Reviewed for Code Compliance
Inspections Division
Approved with Conditions**TIQA Cafe Sign Permit Application**

City of Portland Mail - TIQA Cafe Sign Permit Application

Subject: Re: TIQA Cafe Sign

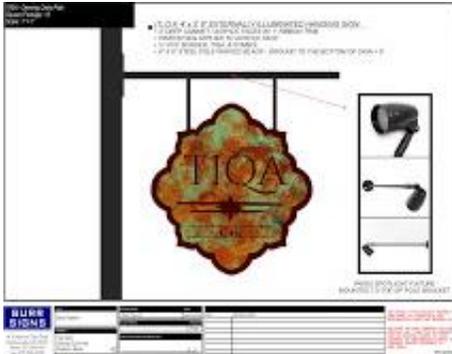
In my previous e-mails, I described the fact that we had concerns about the internal illumination (which has been addressed). I also expressed concern about the thickness of the cabinet. Now that there is no internal illumination, I'm wondering why the sign needs to be 4 inches thick, or even why it needs to be a cabinet. With this type of sign, the sign panel need only be the thickness of the stock material.

Regarding the solar panel, can you tell me where it is proposed to be installed? Also, the specification provided doesn't indicate its dimensions. Is the solar panel proposed because you aren't able to run power to the sign?

Response: Not clear what the issue is. Becoming concerned about this effort. This is the third design I have presented the city and it sounds like you are looking for a fourth. I don't have the energy to keep presenting options nor am I willing to turn over the design of our sign to the city.. There is nothing in any document you presented to me that limits thickness. I am also not clear how 4" is too thick. If you are not willing to approve this, let's go to whatever the next step is.

Response: The installation for the sign is on the corner of State Street just after the parking lot entrance/exit. We are green oriented and didn't want to tear up the grass and sidewalk to illuminate the sign.
